ATRISCO DRIVE CORRIDOR IMPROVEMENTS PH III

RE: **Atrisco Drive Corridor Improvements PH III**
Drainage Calculations
Engineer's Stamp Date - no stamp (File: K12D034)

DRC CPN 5337-02

Re: Atrisco Drive Corridor Improvements PH III

City Project No. COA 5337-02 | Zone Map No. K-12 | Sheet 9-2 Of

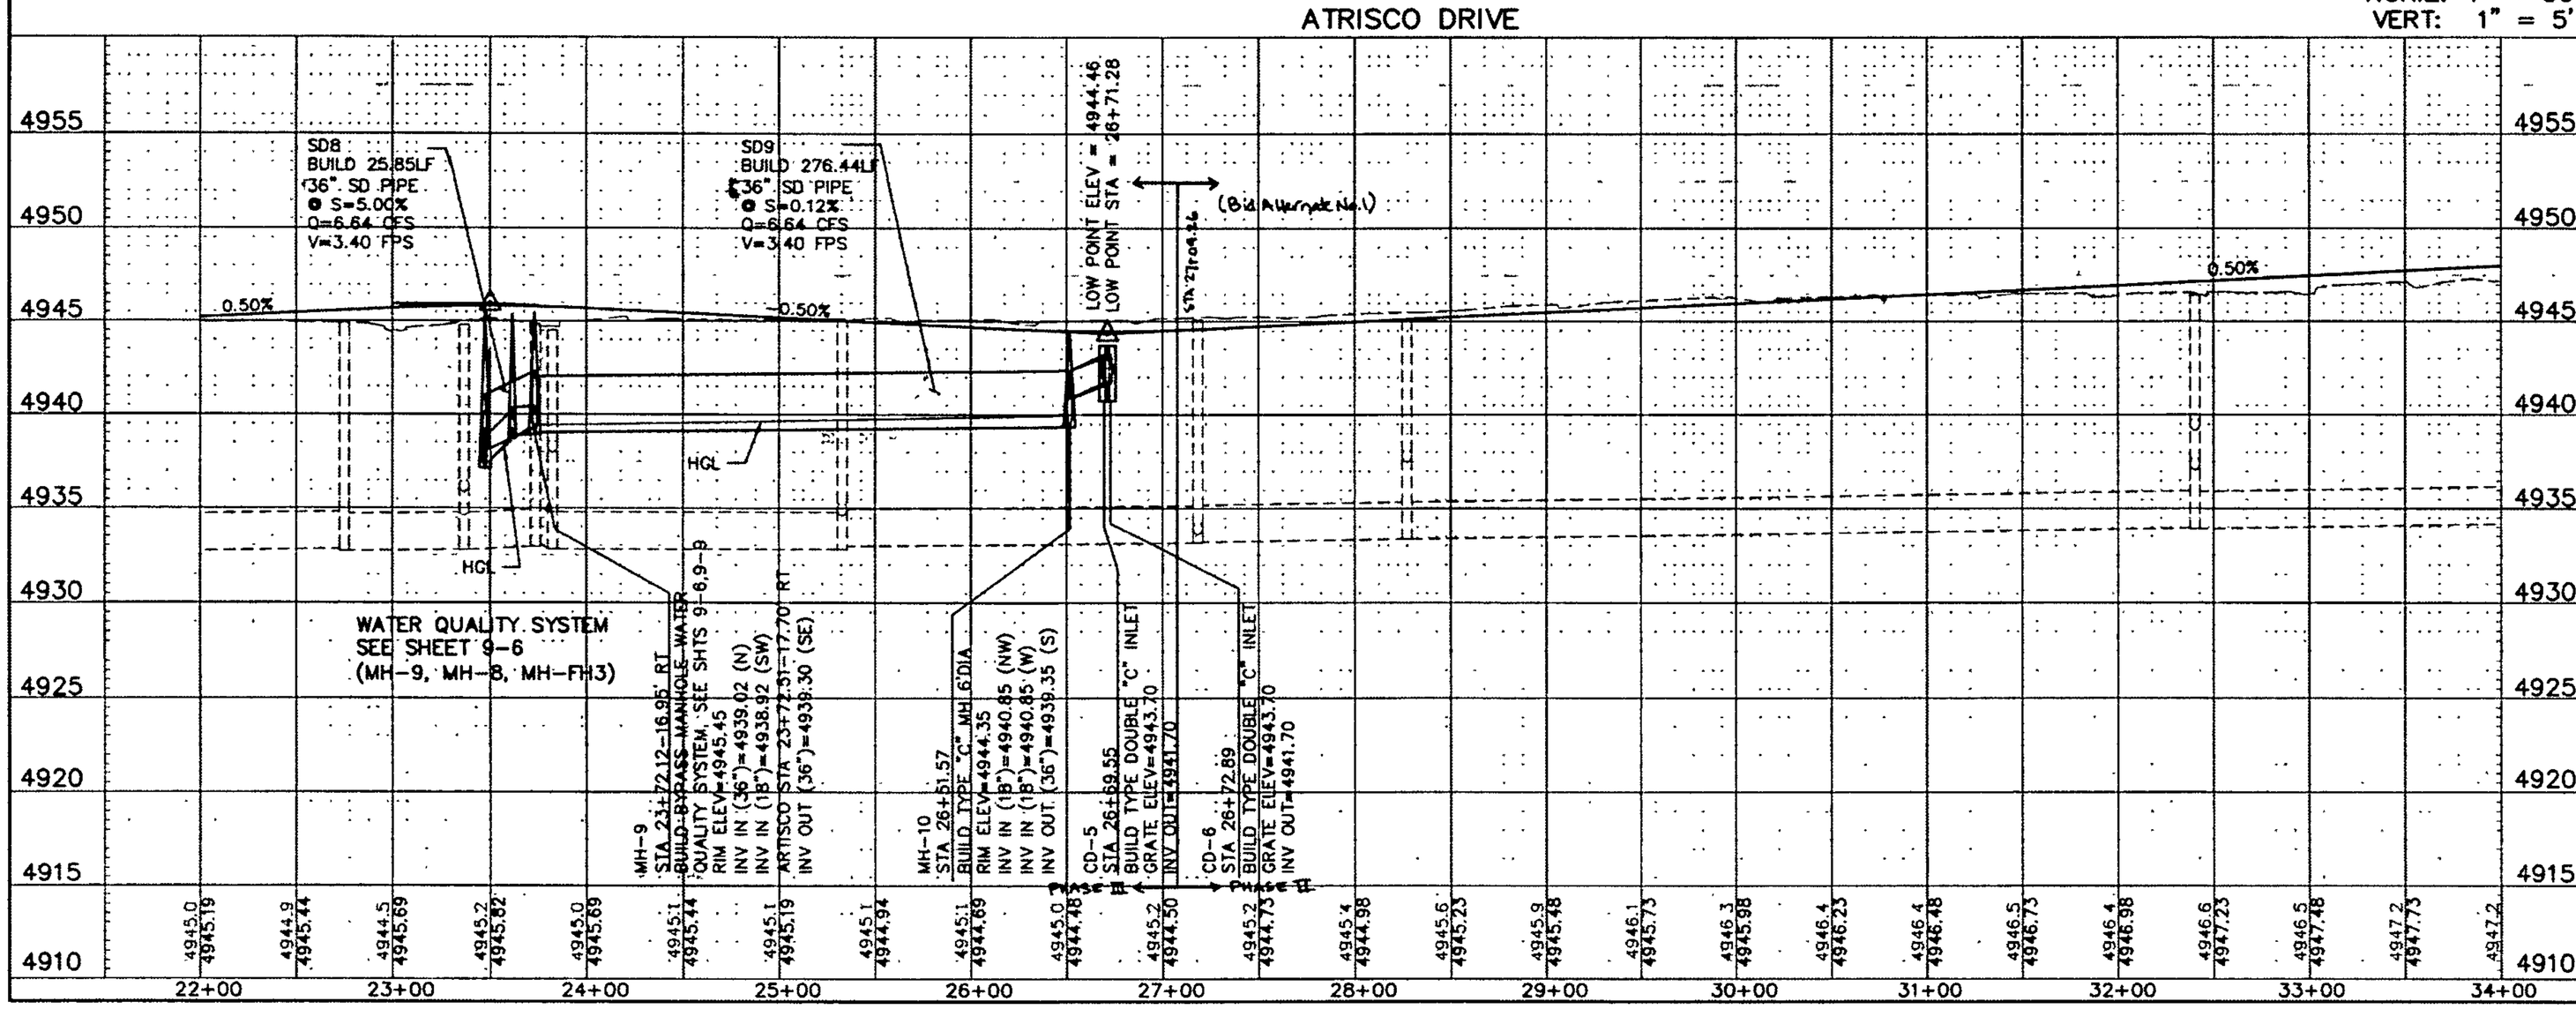
← DBL TH BOAT
& DOUBLE WINE?
TYPE A or
TYPE C
Show capacity
Calcs.

City Project No.	Zone Map No.	Sheet	Of
COA 5337-02	K-12	9-3

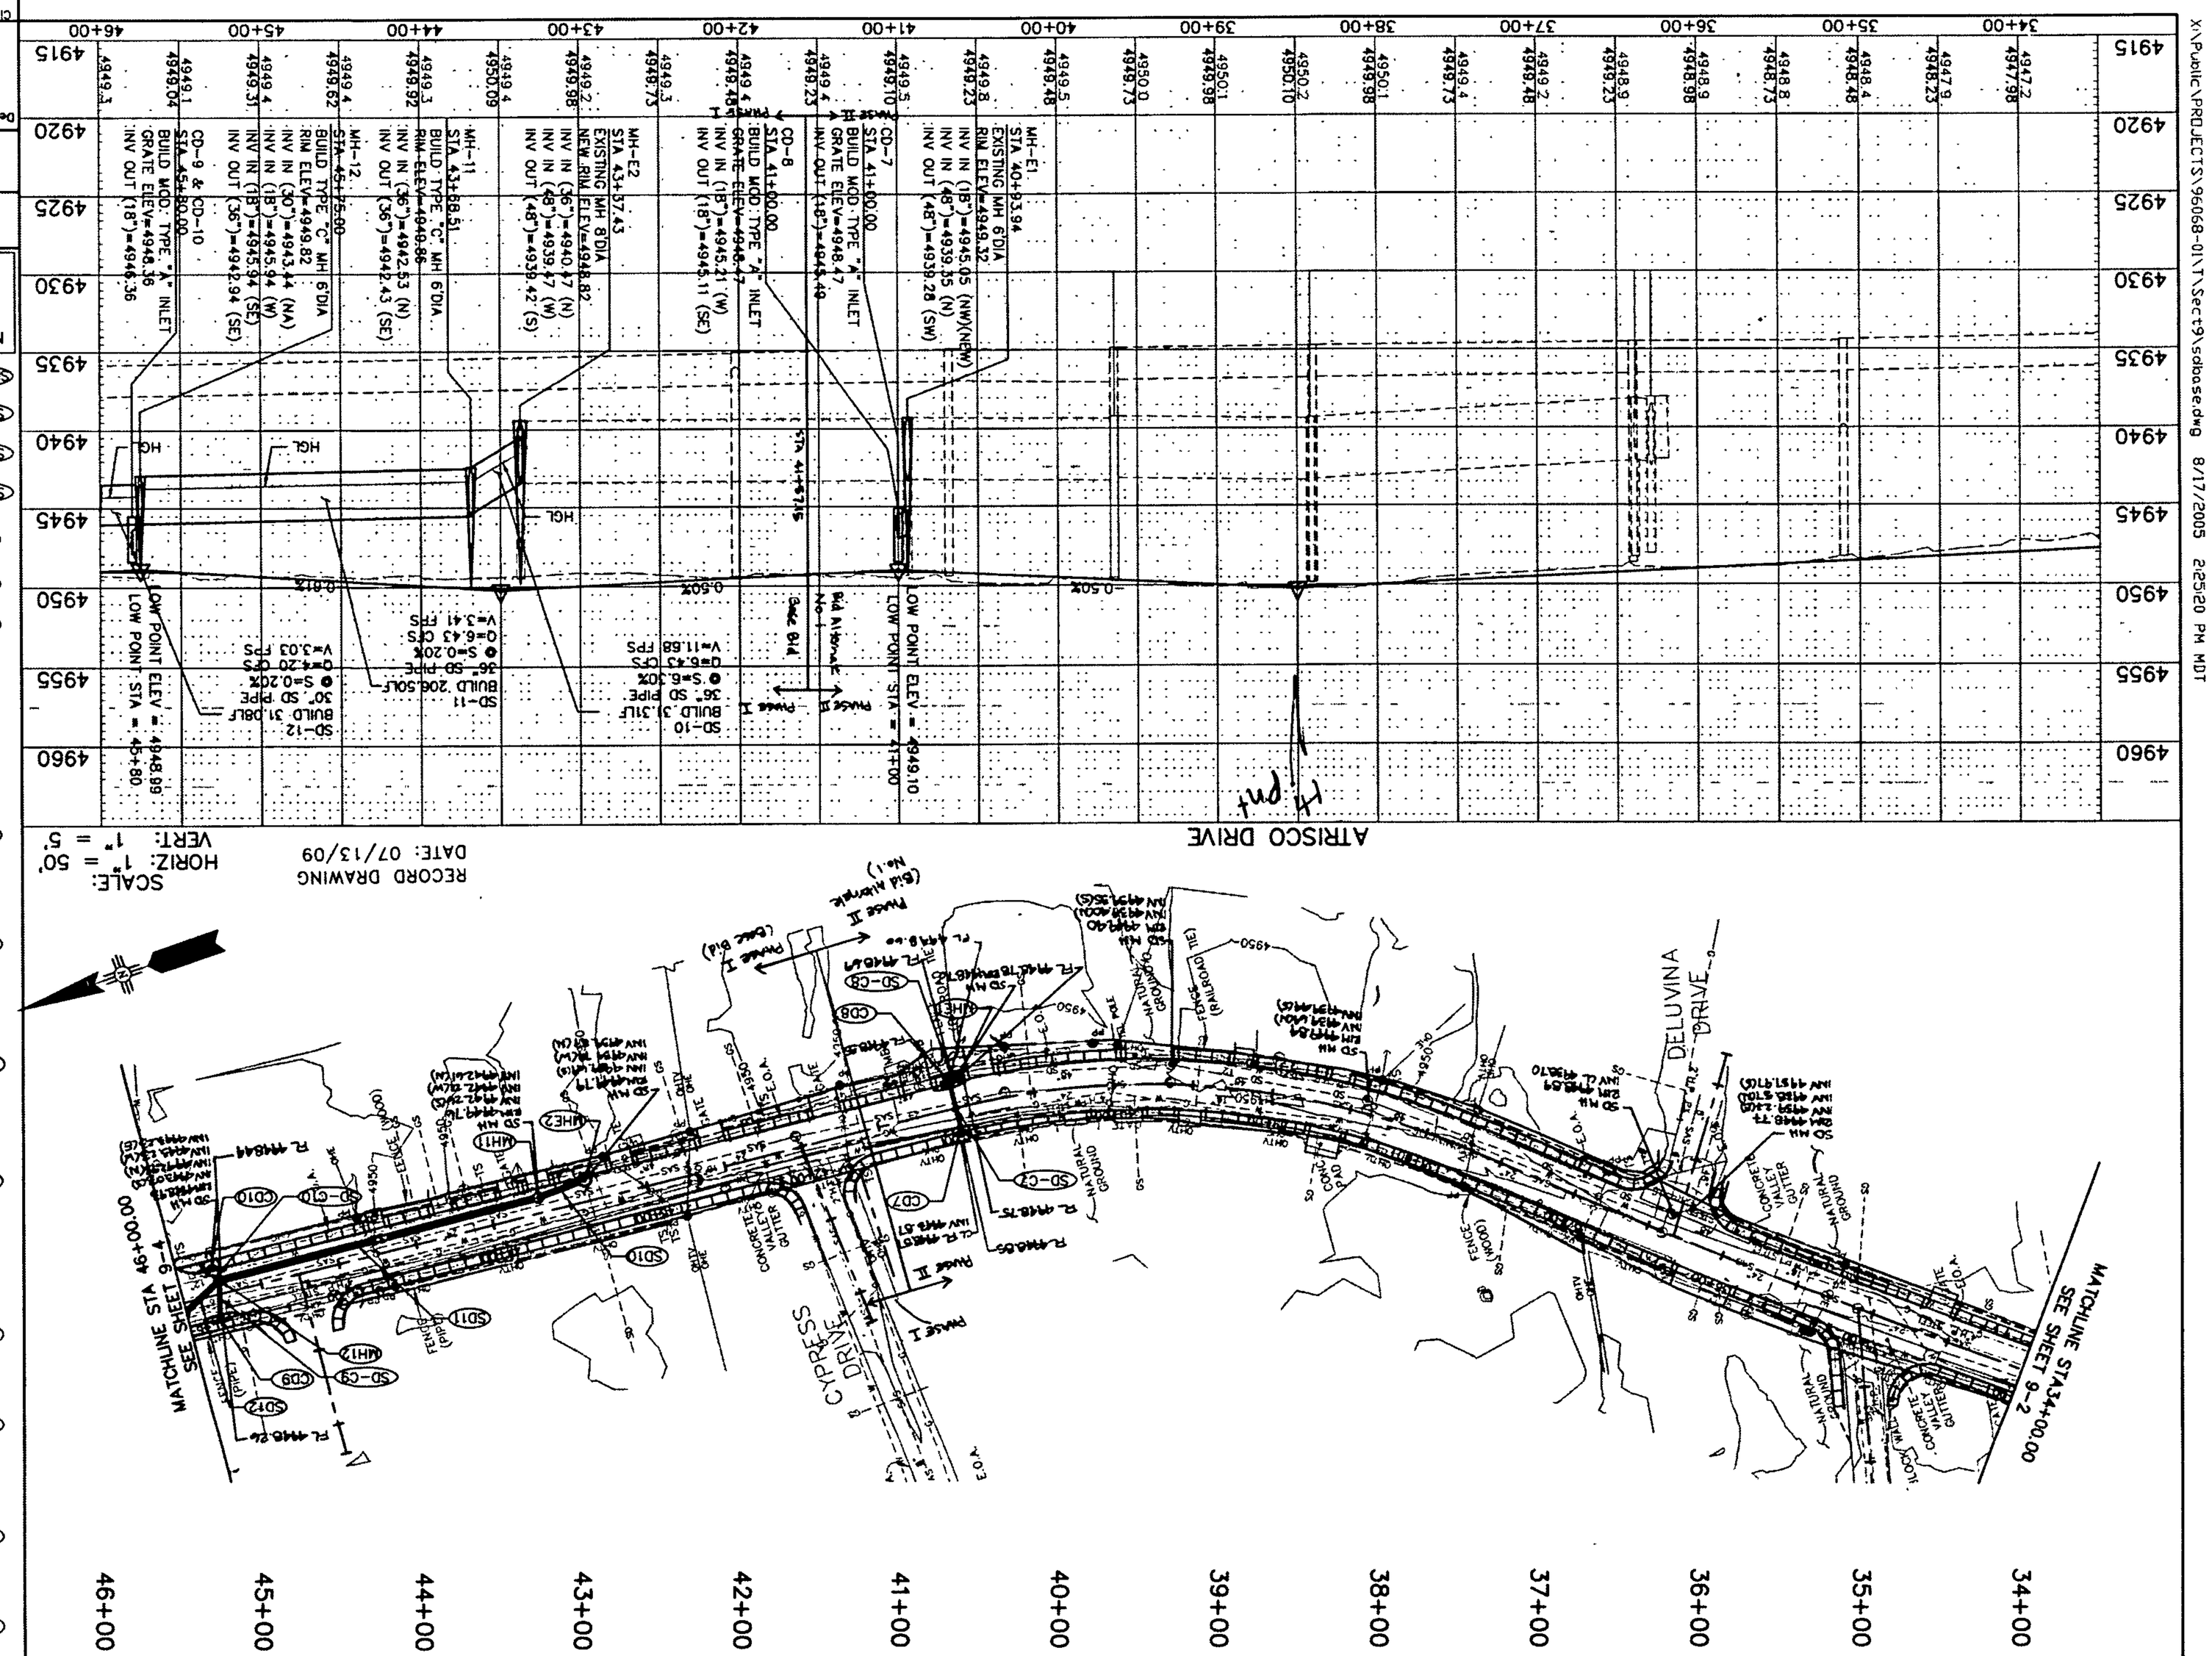
- Modified A inlets – how are these modified? Provide a detail. - Maybe Dbl C throughout.
- Inlets in sump should be double grate. In valley conditions, double wings not necessary.
- Provide calculations to show CD-3 and CD-4 inlets on Sheet 9-1 collect 9.36cfs each.
- HGL on plan set does not match HGL in calculations.
- Explain drainage scheme at Atrisco and ~~Unser~~ Houser Intersection.
- Drive Pad at STA 20+16.99 does not seem to have a high enough water block. Calcs show a depth of 0.4', drive pad waterblock is 0.28'

City Project No.	County Project No.	Zone Map No.	DWG NO.
COA #4938.61	BCC #TS06-07	K-12-Z	9-1

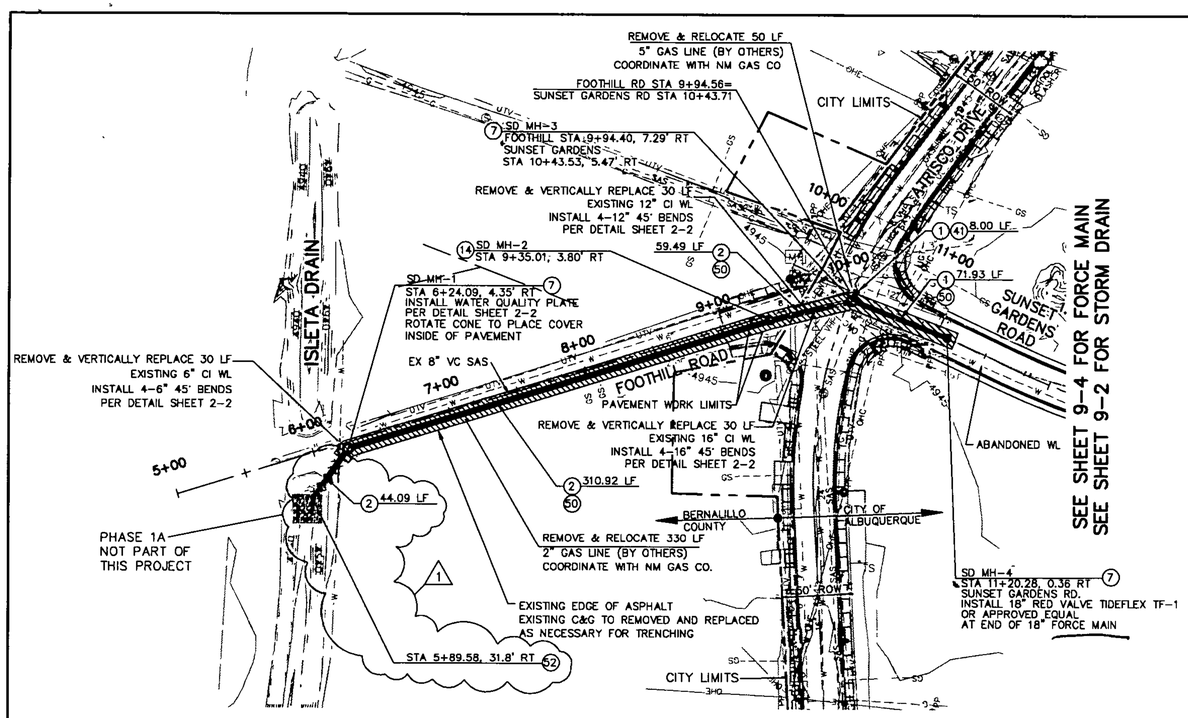
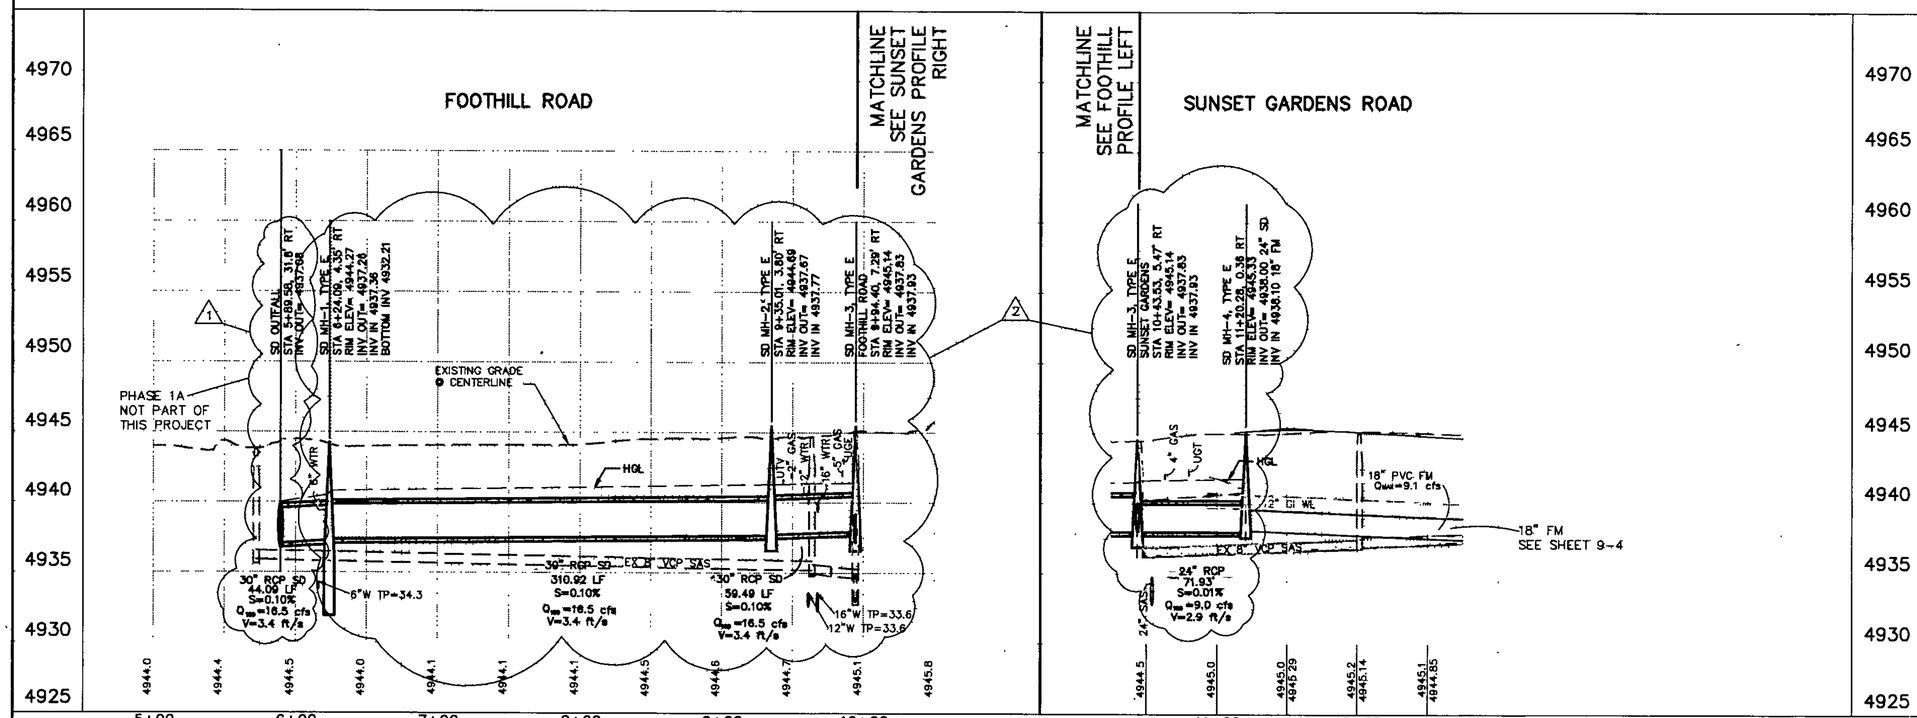
Also, another comment on the DRC set is in regards to FootHill Rd. The Profile looks like its part of this work order , but the plan is greyed out as if its existing. It looks like there are 3 manholes in the profile at that intersection, but only 2 shown on the plan.

Ok...FYI, there will be no work along foothill with this project. we are deleting this sheet from the plans. The storm drain along foothill is existing, as it was built with Sunset Gardens Phase 1 done by the County. The only missing piece is a segment of pipe to connect the storm drain to the Isleta Drain. Originally, we were going to make this connection, but now we are not.
